## LABSS TECHNICAL AND PROCEDURAL DISPUTE RESOLUTION / ALTERNATIVE DESIGN APPROACH TO COMPLIANCE

# CONSULTATION PROCESS FOR USE WITH LABSS CONSORTIA GROUPS; BSD TECHNICAL and PROCEDURAL GROUP AND WITH SFRS (IF APPROPRIATE)

2.9.10 Escape routes - options

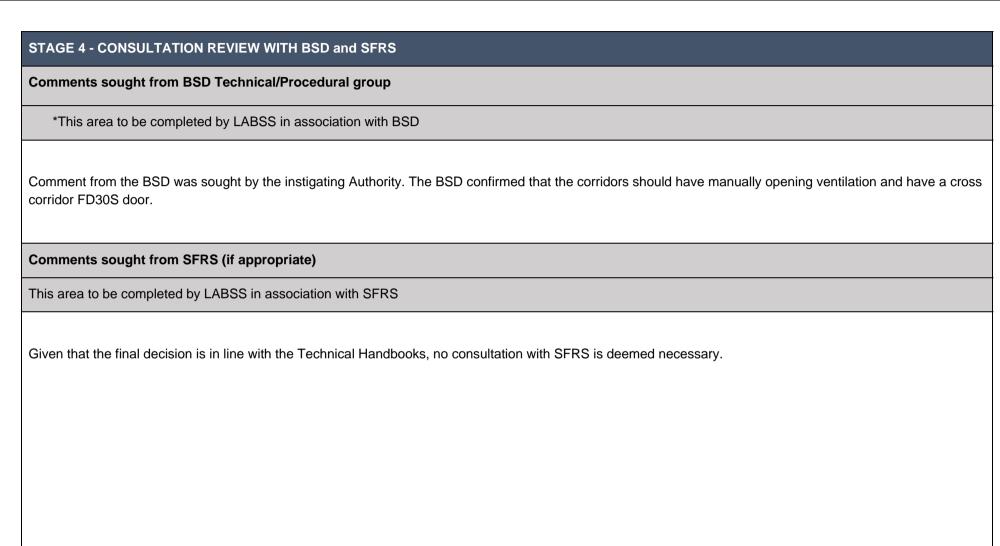
Referring to Figure 2.5

The diagram indicates a corridor with a short duration self-closing fire door (approx. centrally located) and a distance depicted as 30m max from that door to an escape stair.

require to be ventilated. Ventilation would only be required where there is one escape route or a dead end situation exists. Clauses 2.9.14 – 2.9.16 we believe would only apply where table 2.4 calls for smoke ventilation to be provided.

It is our belief that both table 2.4 and Figure 2.5 depict our exact interpretation of the guidance and clearly defines where smoke ventilation is and is not required. Clauses 2.9.14 to 2.9.16 provide guidance of how to achieve compliant smoke ventilation, when it is required under table 2.4 and Fig 2.5.

East Renfrewshire	
	East Renfrewshire agree that smoke extraction will be required.	
	West Dunbartonshire	
	The guidance in Section 2.9.10 table 2.4 for two escape routes references a protected corridor. A protected corridor requires ventilation under 2.9.14.	
	Therefore I agree with Glasgow's interpretation.	
	Inverclyde	
	Irrespective of the height of the building the corridor between the escape stairs requires to be a protected corridor. 2.9.14 and 2.14 both state that protected corridors should be provided with smoke ventilation to maintain tenable conditions.	
	Argyll and Bute	
	I can see where the applicant is coming from if you just refer to Table 2.4 however in 2.19.4 it states that smoke ventilation should be provided to protected corridors, as we know the Technical Handbook derives from British Standards, I have attached an extracts from BS5588. I would say that the BS confirms that smoke ventilation of the corridors is required.

The protected corridor should be provided with smoke ventilation in accordance with the recommendations in 2.9.14.

The diagram in Figure 2.5 Upper Floor – Two Escape Routes is indicative only and is referred to in the additional information below Table 2.4 for guidance on measurement of travel distance. It does not provide all of the relevant information contained within the relevant guidance clauses in relation to a layout which has 2 escape routes.

<del>,</del>	
Whilst not shown on the diagram, and with		
reference to Table 2.4 and 2.9.14, the corridor		
should be described as a protected corridor and		
should therefore be provided with smoke ventilation		
in accordance with the recommendations in 2.9.14.

The LABSS Final Decision in this case is that a protected corridor should be provided with smoke ventilation in accordance with the recommendations in 2.9.14.

The diagram in Figure 2.5 'Upper Floor – Two Escape Routes' should be considered only for the purpose of providing guidance on the measurement of travel distance and should not be regarded as detailing all of the relevant requirements contained within other sections of the guidance clauses in relation to a layout which has 2 escape routes.
